State College Area School District
Ferguson Township Elementary School
Preliminary Daylight Analysis
October 1, 2009

The purpose of this analysis is to determine the daylight performance of the design as of September 2009 and to provide performance recommendations.

2nd Floor North Facing Classrooms

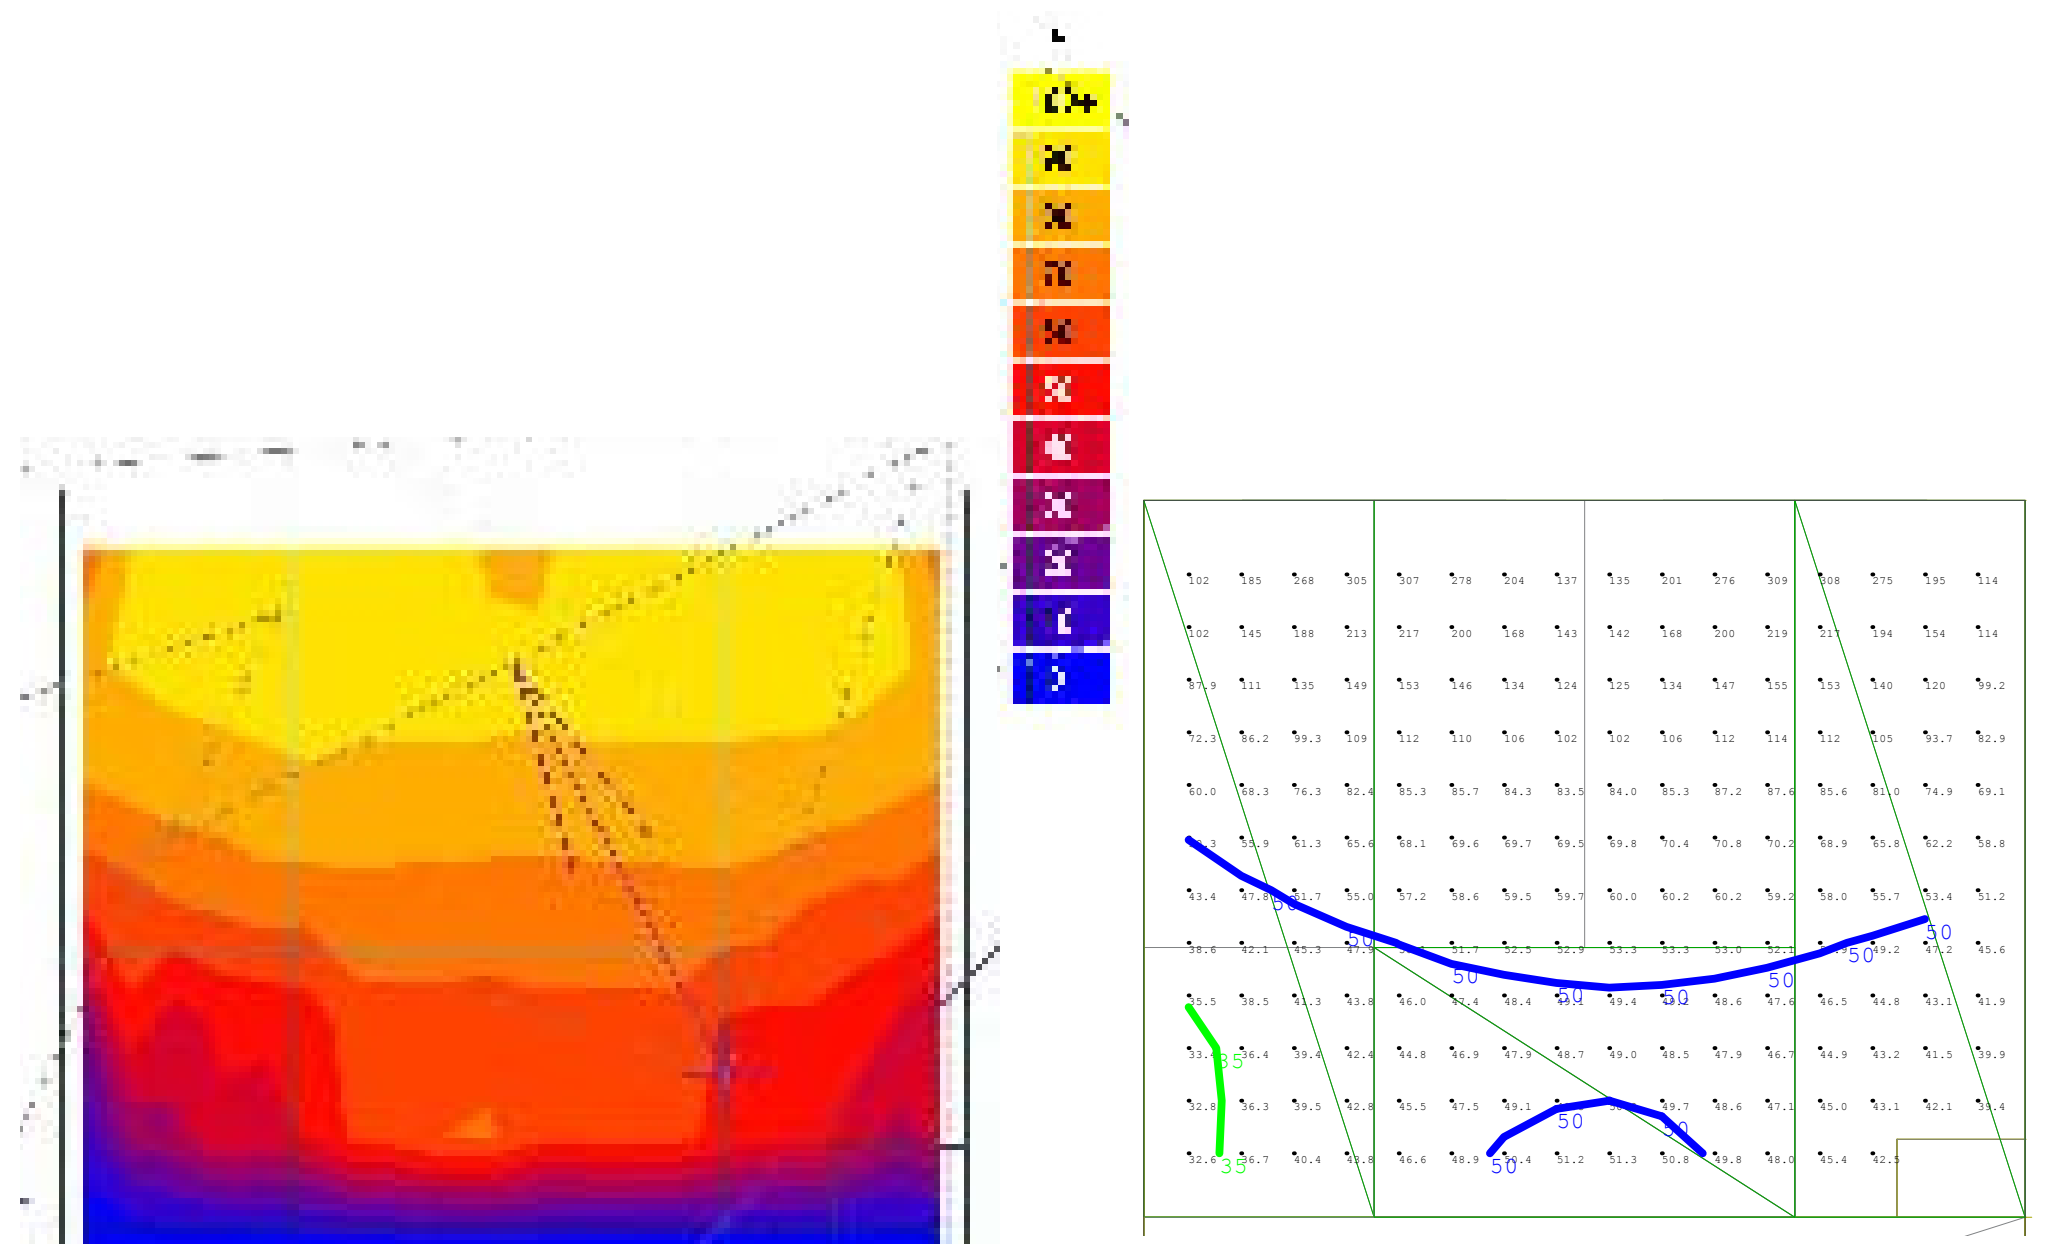
The largest portion of the space is meeting the target DAR. This is due to the bilateral daylighting condition. However, the distribution of light is not as even as it should be due to the clerestory covering only half of the space. Some light loss may also be occurring through the transom window into the hallway.

The clerestory should span the entire width of the space to create a more even distribution of light. There may be some contrast issues because of this.

It is suggested that the transom window to provide light to the hallway be removed. This will bounce more light into a regularly occupied space.

Electrical lighting should be installed to compliment the daylighting. Based upon the analysis and a bilateral daylighting condition it would be feasible to have the first two rows dimmable with a daylight sensor and the third row be stepped switched.

2nd Floor North Hallway

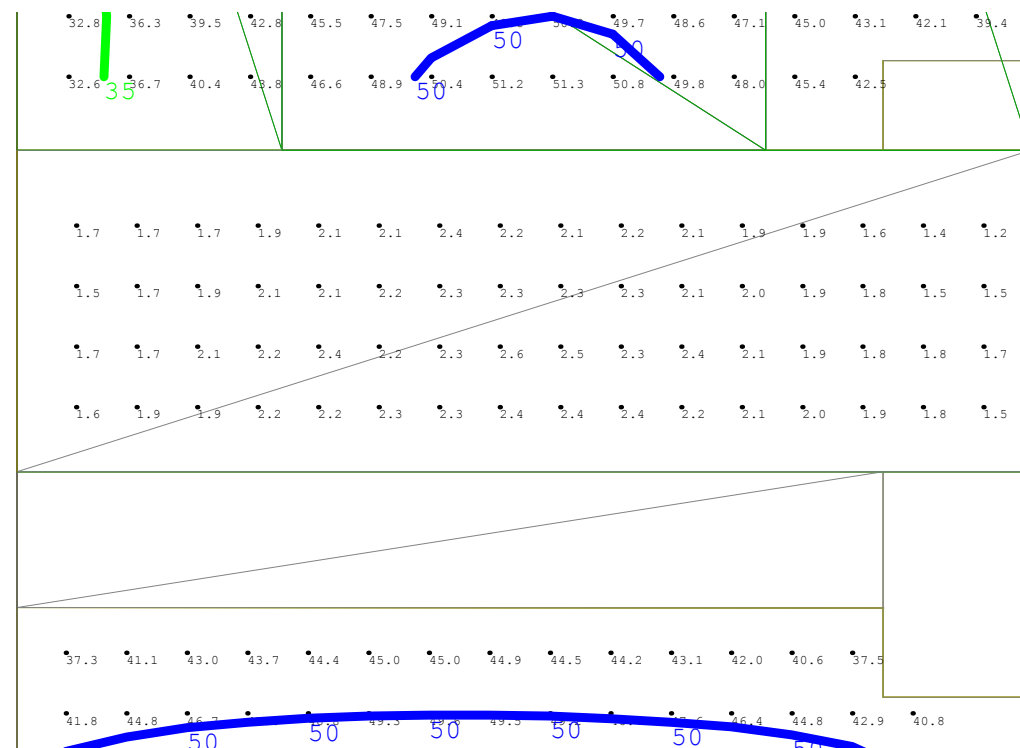
Due to the height of the space and the amount of glass that the light must pass through before it reaches many of the viewable surfaces of the space, it is recommended that the transom window be removed.

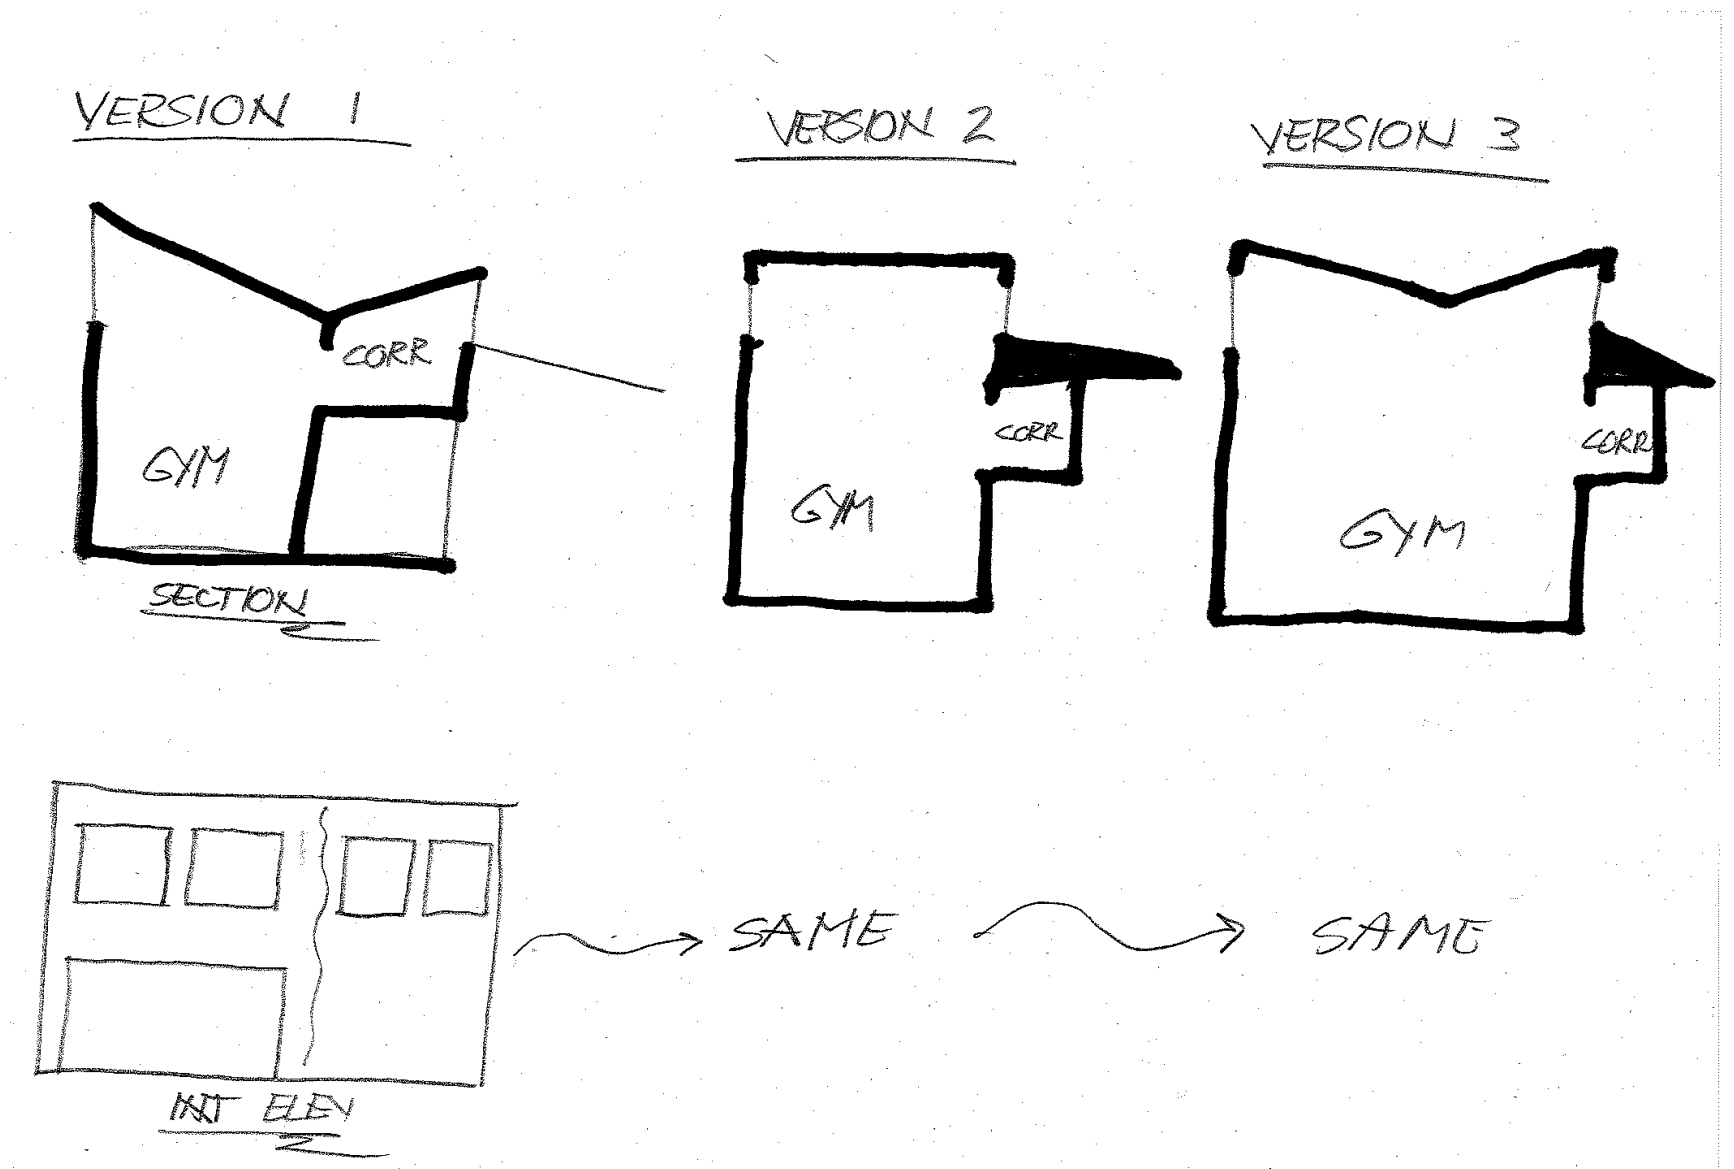
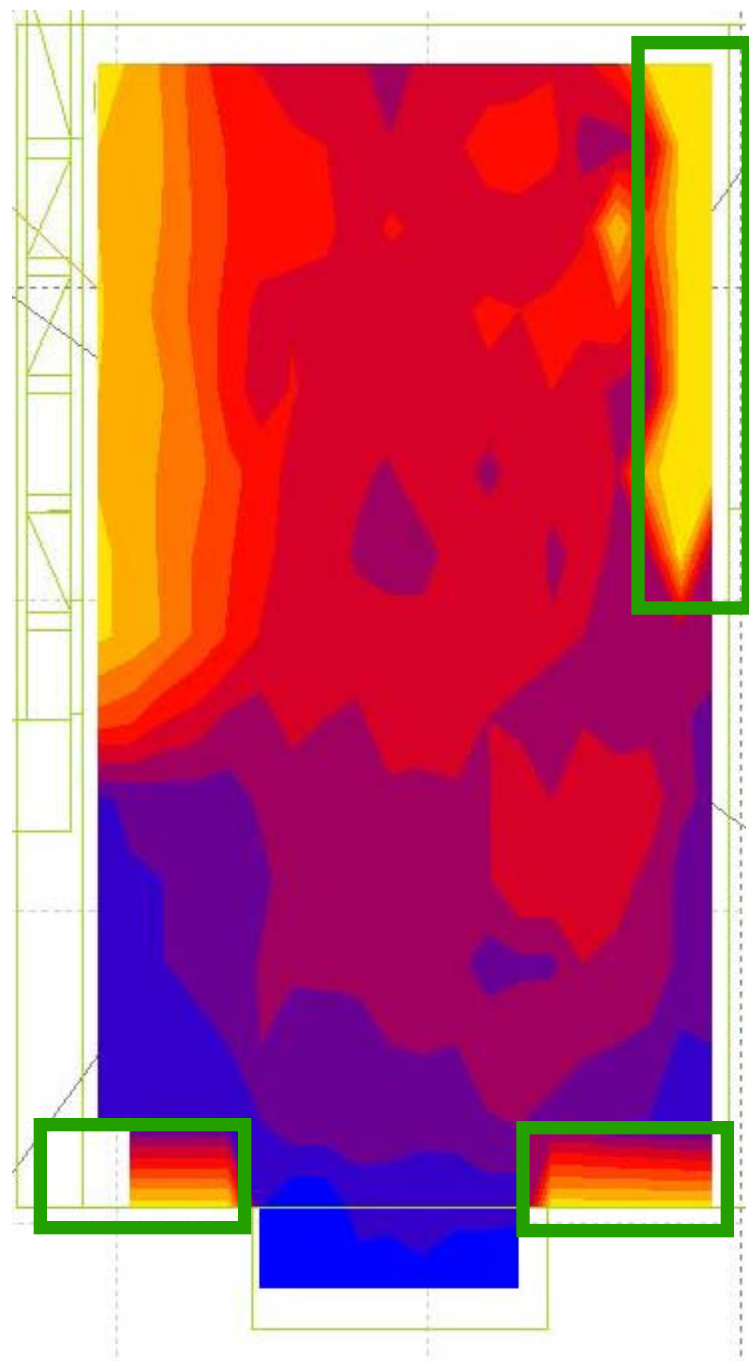
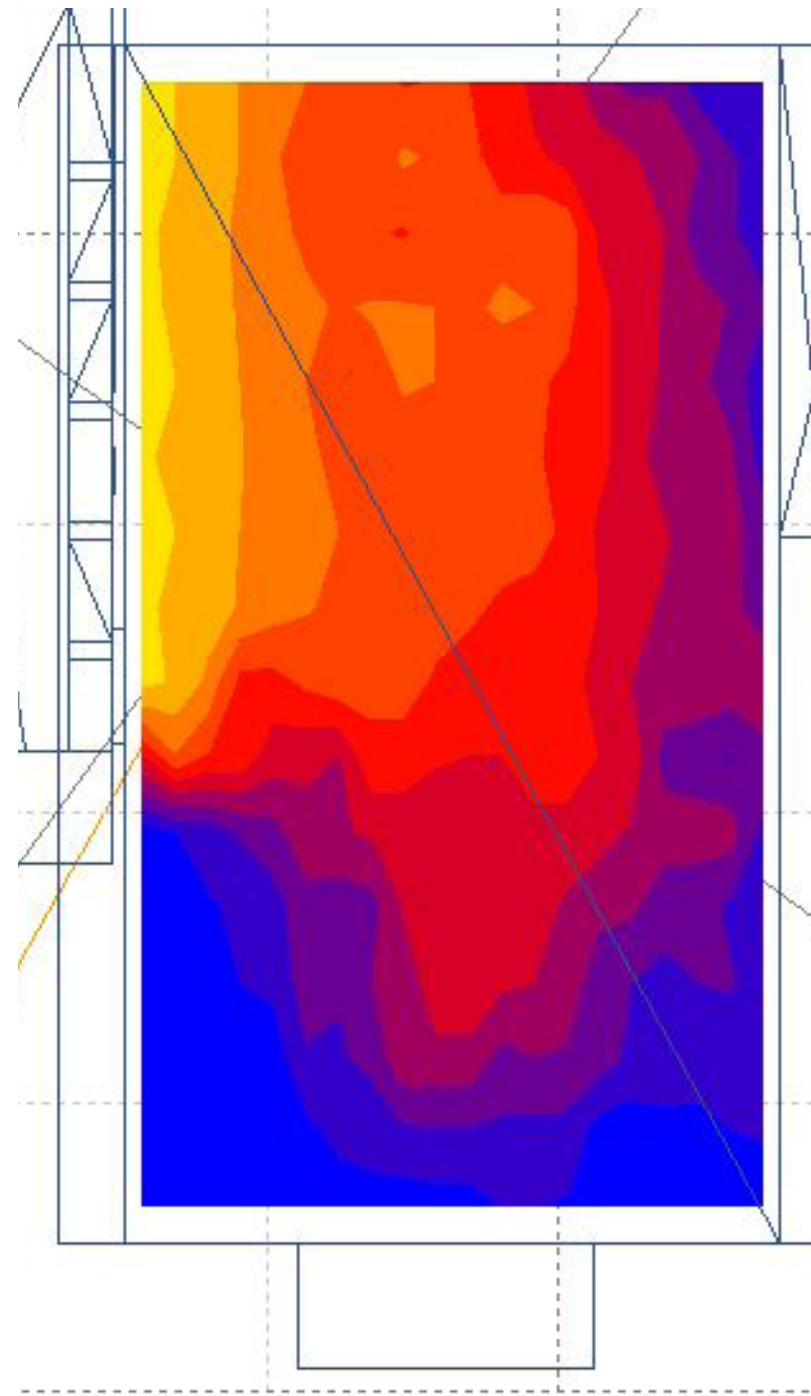
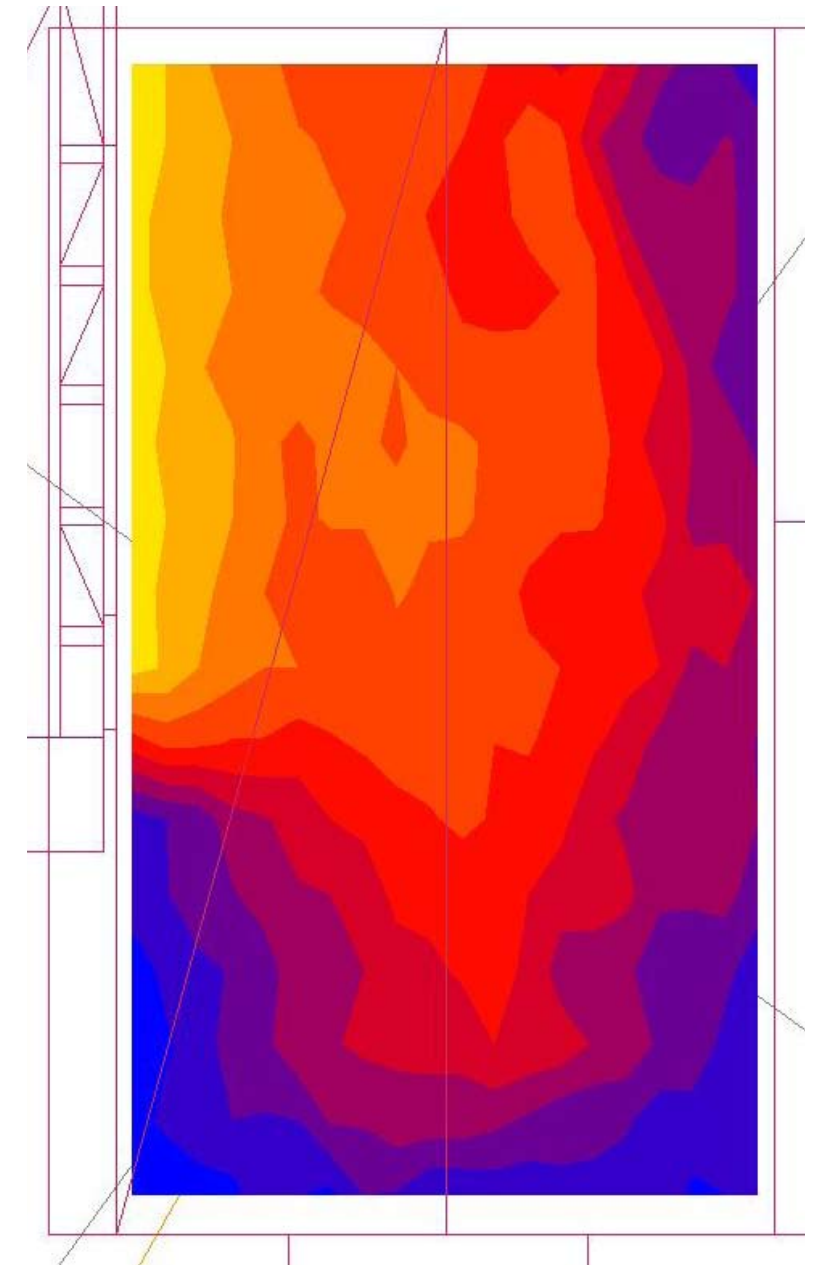
Three scenarios were run to look at three possibilities in effectively daylighting the gymnasium. Scenario 1 is the base design, Scenario 2 has a flat roof with the east clerestory located in the gym, Scenario 3 is the same as 2 except the roof is a butterfly roof.

The target DAR for the gymnasium is 80% with a minimum illuminance value of 35fc. The scenario that comes the closest to that goal and provides an even distribution of daylight in the space is Scenario 3.

To meet the daylighting goals and to provide the best quality of daylight into the space, it is recommended that scenario 3 is used.

It has been noted that glazing at the floor along the west facade will remain. A glazing with a VLT of no more than 50% should be used. It is recommended that the amount of glazing be reduced and the entry roof be extended and or angled to help reduce the times of direct solar penetration.

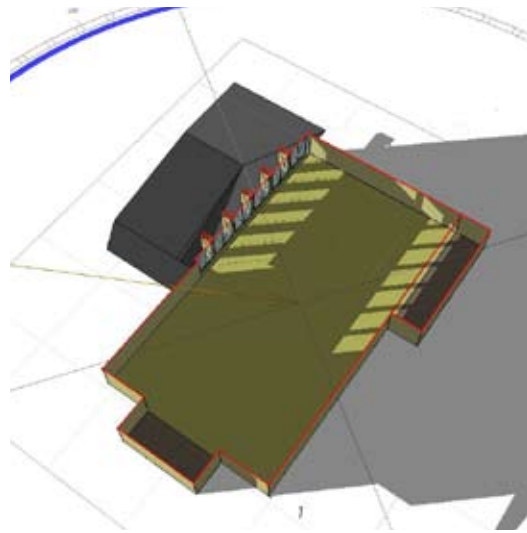
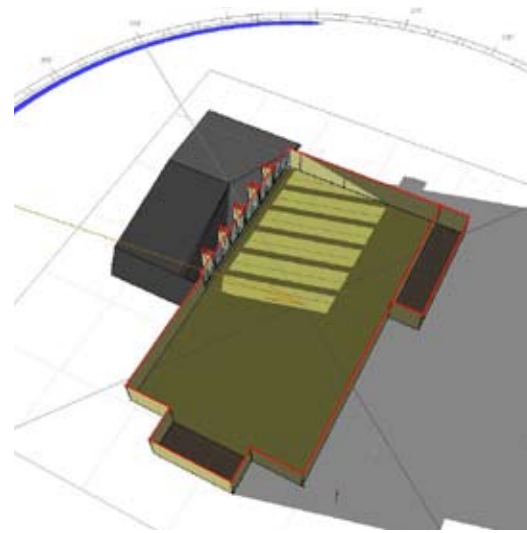
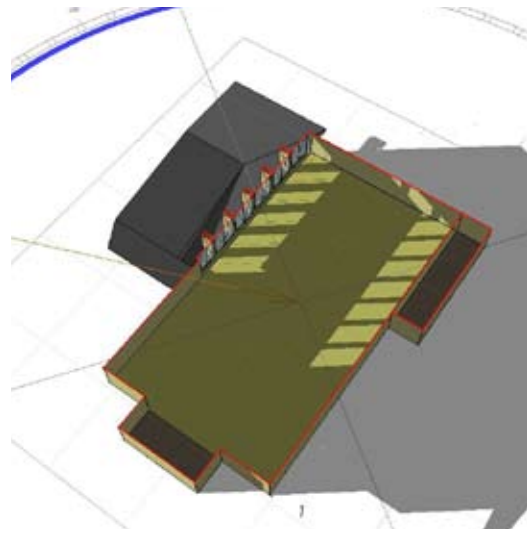
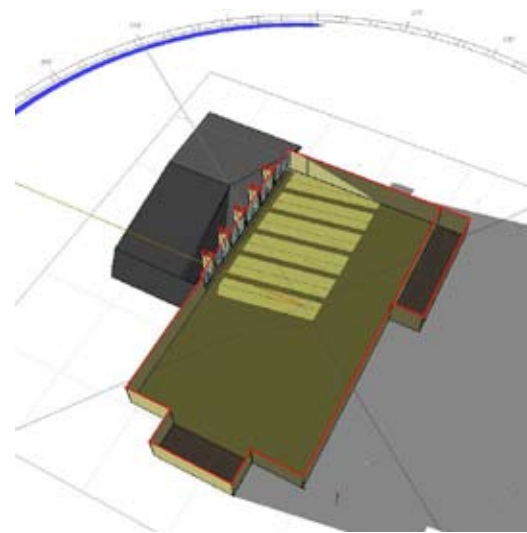
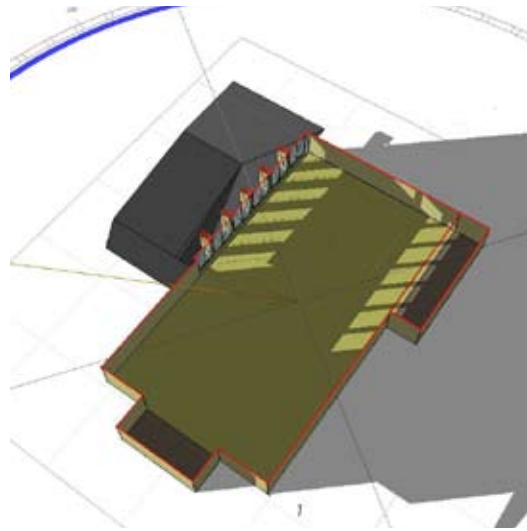
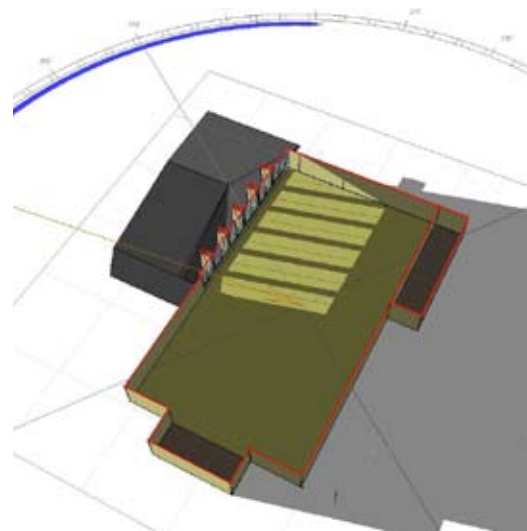
From the beginning of October till the end of March, there will be issues of direct solar penetration. In those months, this will occur during the school day. As the year moves on, from March until September, the effects will be greater later in the evening.

The main focus is to reduce this issue during the school day. If the overhang is extended 2'-0" and dropped 2'-0" in height, this will almost completely eliminate the occurrence of direct sunlight onto the playing surface. Another option is to angle the overhang, the exact angle and length has not been determined until this option is discussed with the design team.

The only really effective means to eliminate the direct sun from the entering the space in the late afternoon and early evening hours is to eliminate the glazing. This scenario will also produce glare in the space causing discomfort to the occupants. If this glazing is not removed, then is recommended that a glazing with no more than a 50% VLT be used. The use of a solar shade would reduce the effect of glare and direct solar issues in the space.
